**PROPOSED CHLORIDE PROCESS  
TITANIUM DIOXIDE PLANT  
AT KEMERTON**

**SCM CHEMICALS LTD**

**Report and Recommendations  
of the  
Environmental Protection Authority**

Bulletin 283      July 1987

Figure 4. Modified wastewater disposal system.

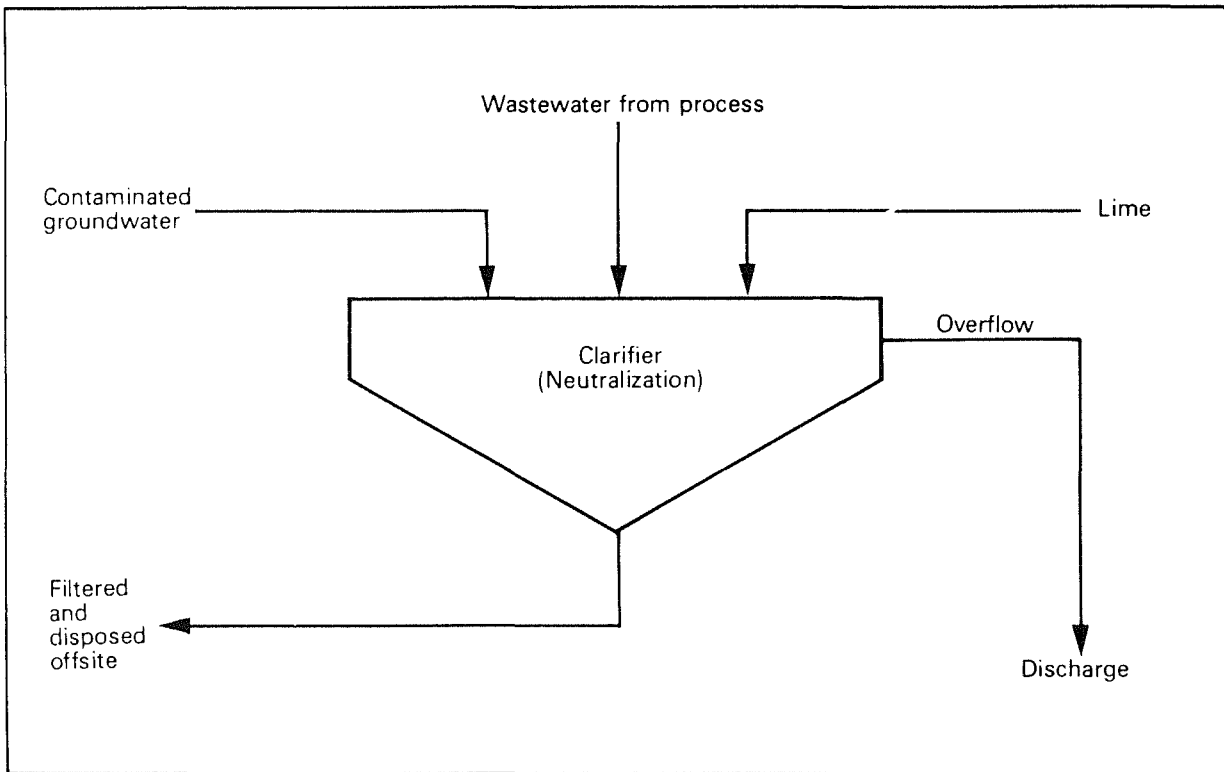
The proposed wastewater treatment system is shown schematically in Figure 4. This consists of collection, lime-dosing for precipitation, and neutralisation through clarification.

Figure 12. Existing Land Use, Distribution of Dwellings and Risk Contours

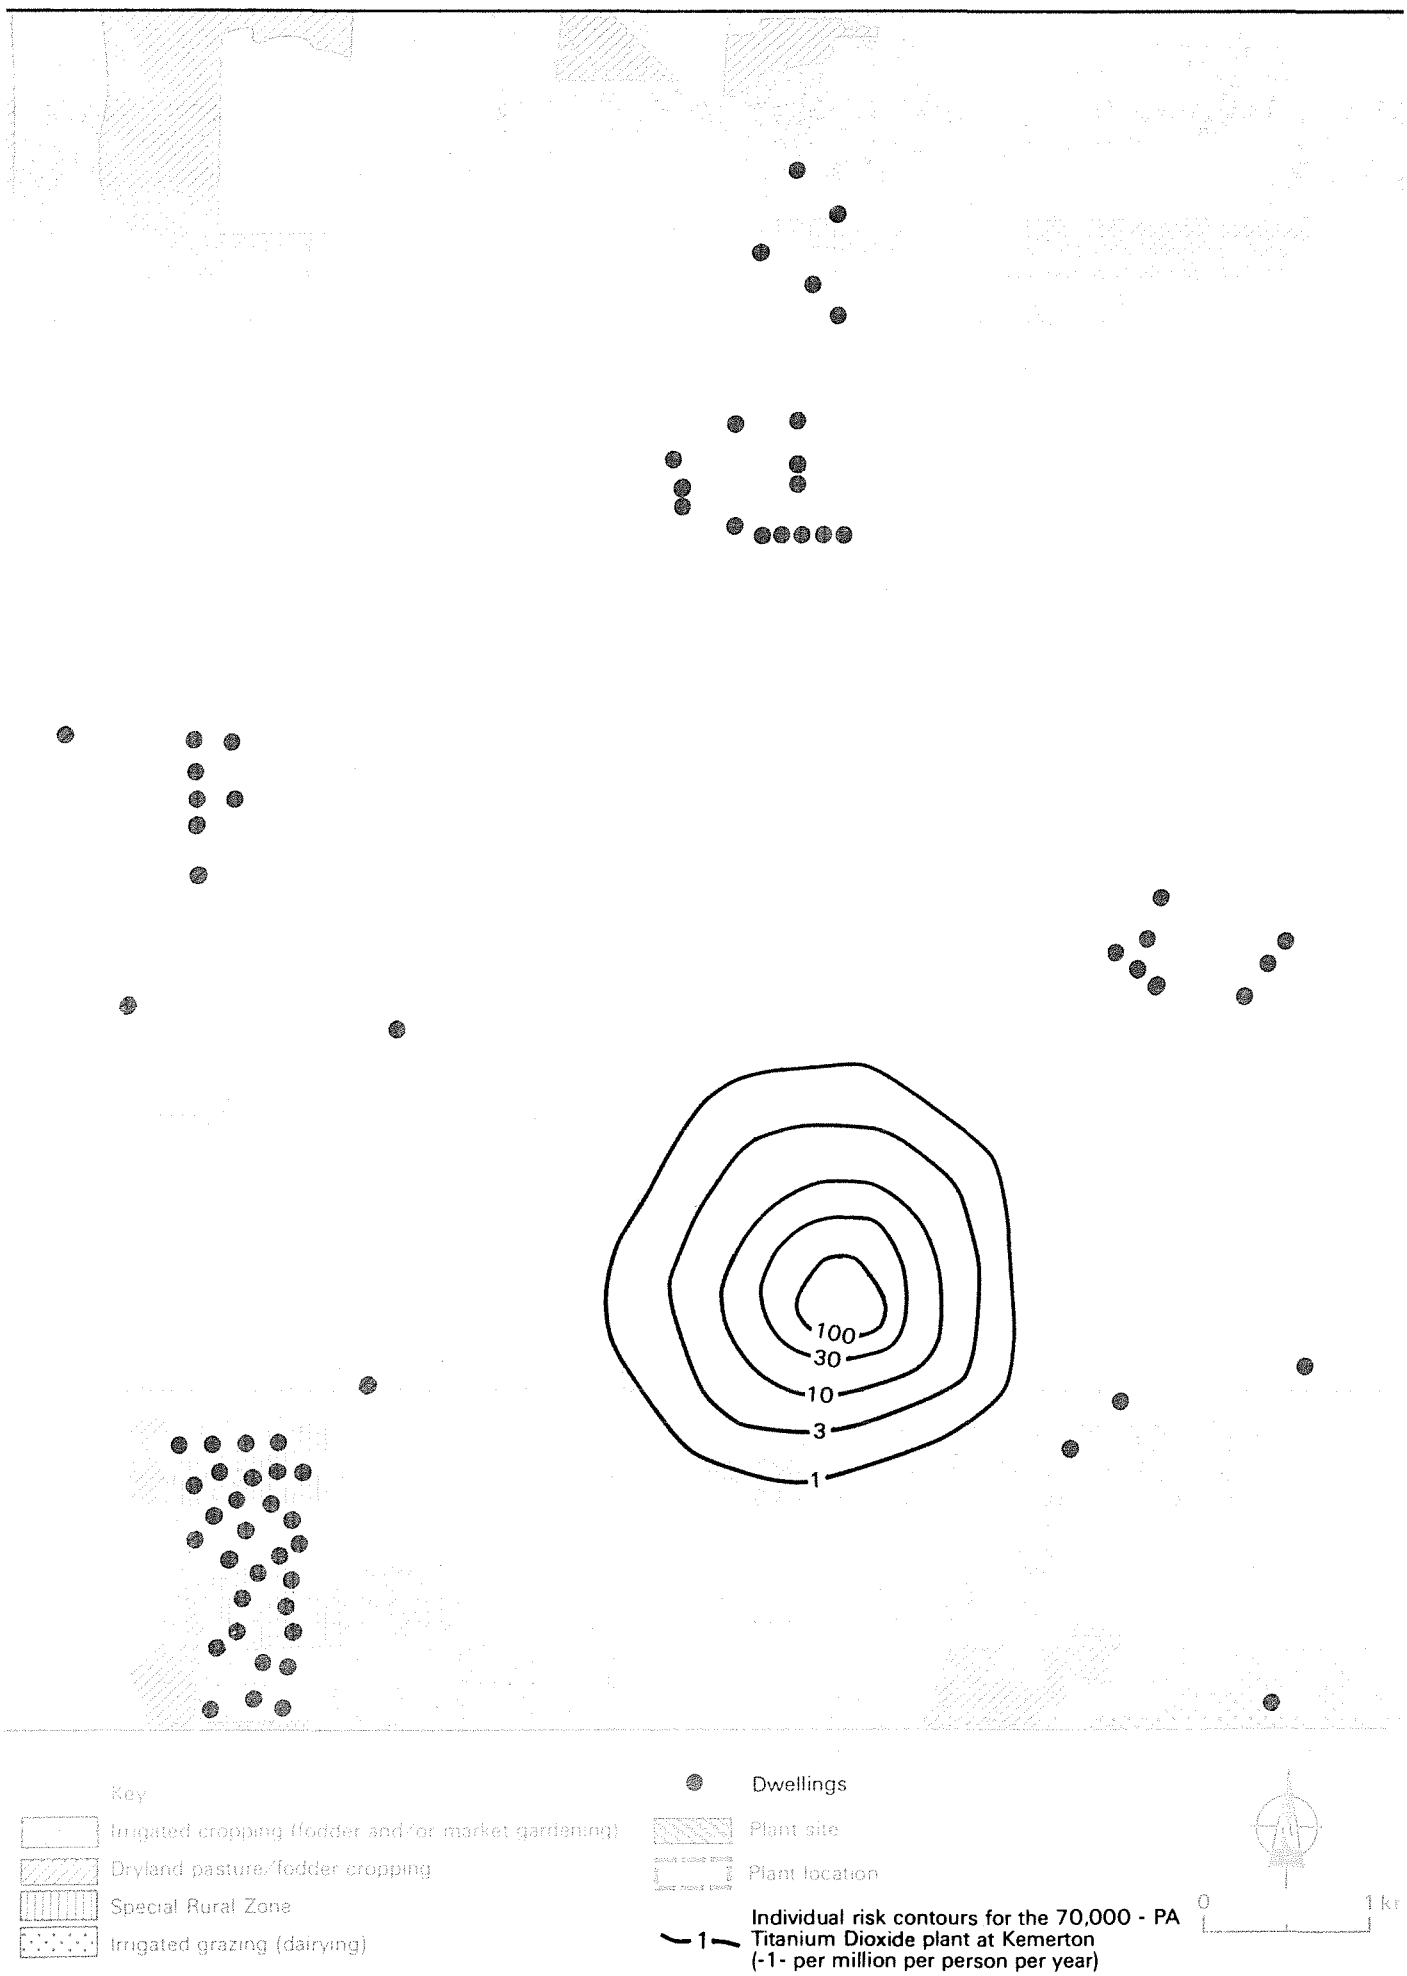
The risk levels that would be generated by the proposal for the Kemerton site are presented in the NOI. These risk levels for 100% outdoor are shown in Figure 12. The Appendix to the NOI states that "Cremer & Warner conclude that this location (Kemerton site) is suitable for the proposed plant (storing 50 tonnes of chlorine) as no residential property would be subject to an individual risk greater than  $1 \times 10^{-6} \text{y}^{-1}$ " (Cremer & Warner 1987).

Due to its assessment of the Australind proposal the Authority has a large quantity of technical information which was used by the NSW Department of Environment and Planning to model the likely risk levels to be generated for this proposal. DEP has advised the Authority that likely risk levels to be experienced from the proposed plant at Kemerton would be as presented in the NOI. This analysis agrees with the risk results for the 50 tonne storage of chlorine (as 2 x 25 tonne storage vessels) as shown in Figure 12.

- . an audit of risk and hazards to be submitted to the EPA upon request.
- (4) The Environmental Protection Authority recommends that no more than 50 tonnes of chlorine should be stored at the Kemerton plant location in containers not exceeding 25 tonnes capacity.
